**0001 Technical Service Information**

Concerns:	<b>14-32132-01 = 10 x OE No. 56 07 937</b> <b>14-32132-02 = 12 x OE No. 56 07 937</b>
Make:	Opel
Model:	Agila, Astra, Combo, Corsa, Meriva, Tigra
Engine code:	X10XE, Z10XE, X12XE, Z12XE, Z14XE

## New cylinder head bolt without washer

Fig. 1\_Old/replaced bolt with washer (OE No. 607 926)

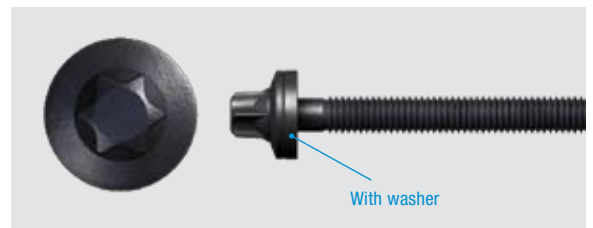
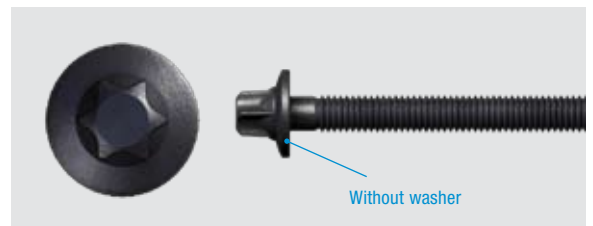
Opel has replaced the cylinder head bolt with original number 607 926 and captive washer with the original number 56 07 937 bolt without washer. The new bolt is slightly shorter so that it must be installed without a washer. From now on, when the "old" bolt with washer must be removed during a repair, the new bolt without washer must be installed.
